Assessment Officer Report

Permit No PA2402930 11 Beach Street,
Frankston

Officer Assessment Report
Development Approvals & Design

Figure 10 floorplate based on preferred setbacks (DTP markup)

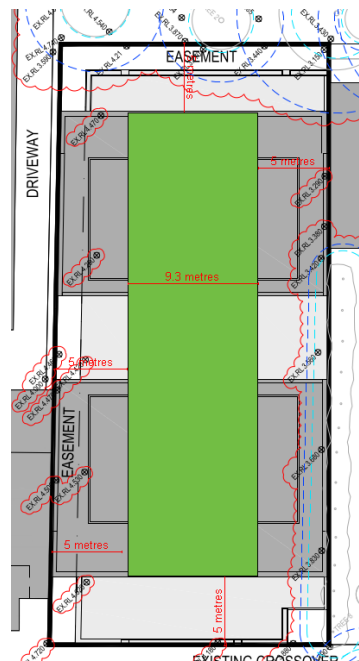
78. The building is setback 0m from the side and rear boundaries and does not meet the preferred 5m setbacks under DDO5 and the draft ACZ1.
79. The side and rear setbacks are considered acceptable given the location of the site within a metropolitan activity centre which has an evolving character moving toward higher density development. The proposal will not affect sensitive residential uses and will provide for equitable development for the east adjoining property to replicate if it is developed in future. West boundary walls approximately match the length of adjoining commercial building at 411 Nepean Highway and will be located adjacent to a driveway of the commercial building at 405 Nepean Highway which provides separation.

80. It is considered that the preferred setbacks may present difficulty in achievability for the subject site given its dimensions as shown in the markup prepared by DTP at Figure 10. This would limit the feasibility of potential floorplates for any development on the site.

81. The council has outlined that for the subject site to redevelop to the proposed height, it would need to be consolidated with an adjacent site, to facilitate the provision of upper-level setbacks to side boundaries. This is considered a high expectation given the site is not unreasonably small at 829m².

Figure 12 Beach Street section for shadows from FMAC Structure Plan: Urban Design and Planning Assessment, Tract, 2022

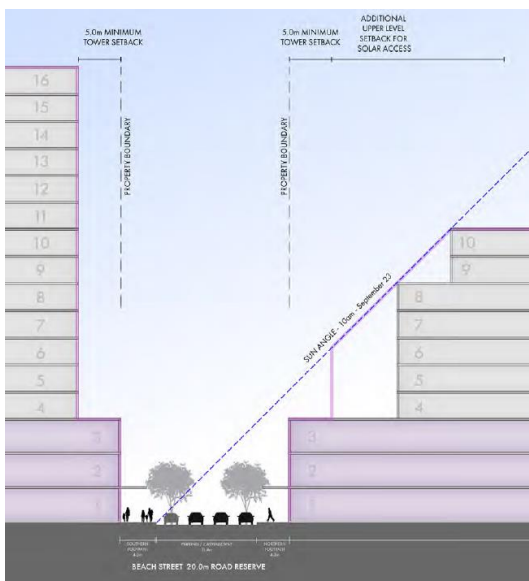
124. The DDO5 requires consideration of shadow consistent with the FMAC Structure Plan 2015 which includes a built form principle that new development should maintain sunlight to footpaths on the opposite side of the street and adjacent public spaces.

125. The draft ACZ1 seeks solar access to be maintained to the entire southern footpath to the kerb line between 10am and 2pm on 22 September. Given the preferred height of 41m in the draft ACZ1 it is not considered feasible that this will be achieved. The *FMAC Structure Plan: Urban Design and Planning Assessment, Tract, 2022* provides a technical assessment that has partly informed the FMAC Structure Plan, 2023. The Urban Design and Planning Assessment includes massing and shadow testing that shows that significant setbacks would be required, greater than the 5m preferred minimum, to achieve solar access to the southern footpath within the specified heights (refer Figures 12 and 13). The assessment notes that *testing demonstrated that sunlight is achievable in this period whilst allowing for generous building envelopes. Future development on the north side of Wells Street and Beach Street are impacted most by the sunlight requirement as they are narrower than other streets and buildings cast a shadow to the south.*

Figure 14 west elevation (wind vent outlined)

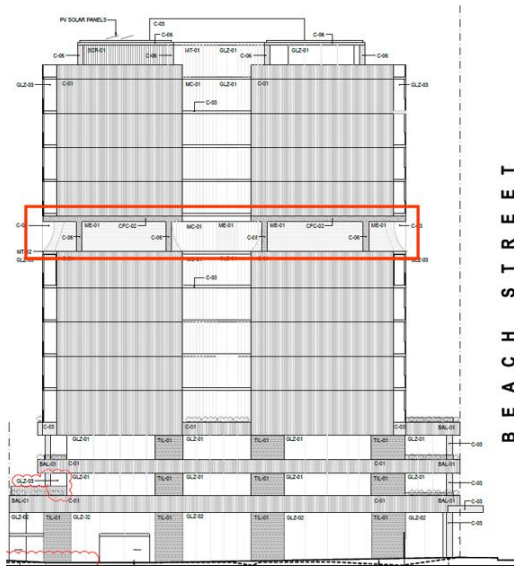
130. The mitigation strategies recommended by MEL Consultants to achieve the above wind conditions include venting a level midway up the tower and balustrade heights of 1.8m on the west side of balconies facing the beach. These mitigation strategies have been reflected on the plans.

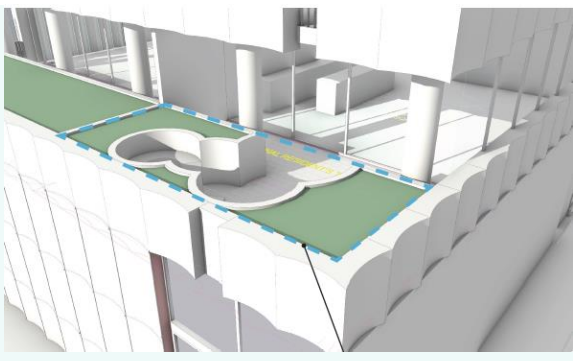
113. Rooms facing the internal light wells have windows that have limited openings to provide restricted directional views outward. Fluted glass will be used at low-level of windows to provide privacy, with vision glass at high-level to provide outlook and maximise daylight.

Vision glass at high-level to provide outlook & maximise daylight

Fluted glass at low-level to provide privacy
